Independent Review of National Grid's IED Investments: Ofgem Submission

Client: Ofgem

Date: June 2015

Figure 1 – Cost Benefit Analysis 1500 [sic] Hours LCP Case (Actually 3000 hours case) [7]

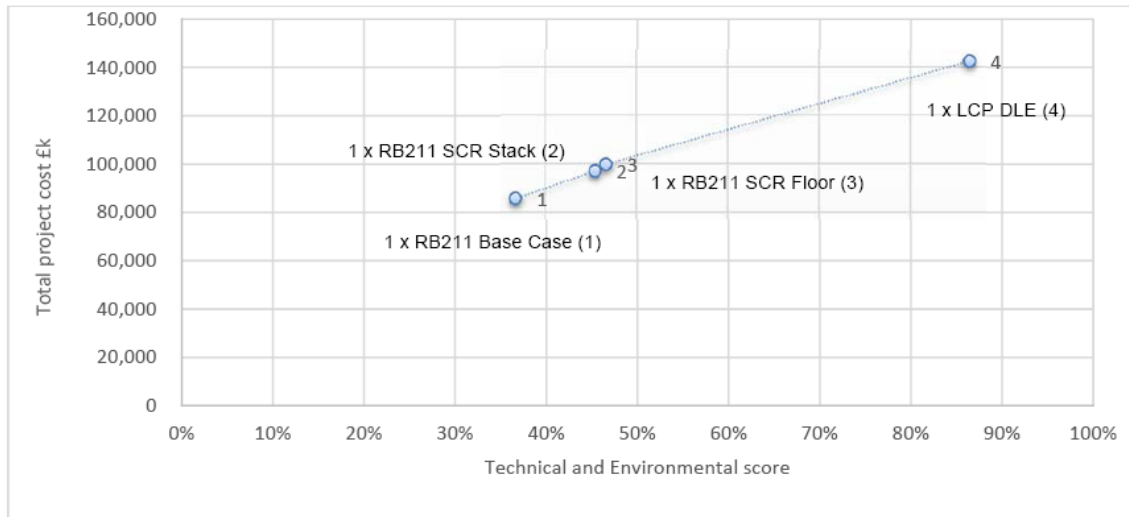
It is apparent from Figure 1, reproduced from the SCR BAT report [7], that the SCR options are given a similar cost to the base case of doing nothing. This is because most of the costs are associated with the maintenance of the existing RB211 turbine.

“RB211 and Avon maintenance costs (base case and catalyst options) are likely to be an overestimate of the true cost of maintaining these units.” [7]

Thus the actual cost of an SCR solution may be considerably lower than estimated.

Figure 2 – NGGT example of a potential operating envelope for a new compressor with the 70% load line superimposed (the blue bordered area is likely to be above the ELV).

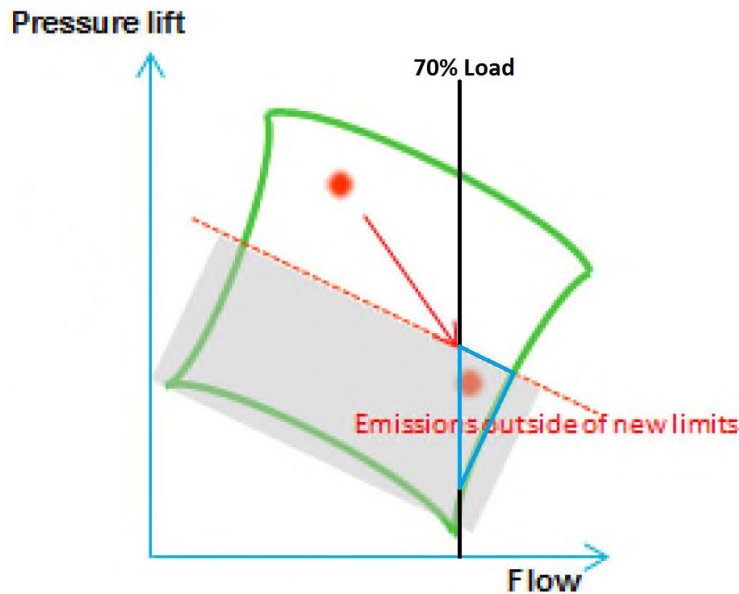
Figure 2 below is adapted from the NGGT submission [1]. It shows the 70% load line superimposed on the NGGT potential new operating envelope. This means that the only area where emissions are likely to be above the ELV is inside the small area bounded by blue, not the whole of the grey area.

Technically this draws into question the stated need to replace a single large unit with multiple smaller units.
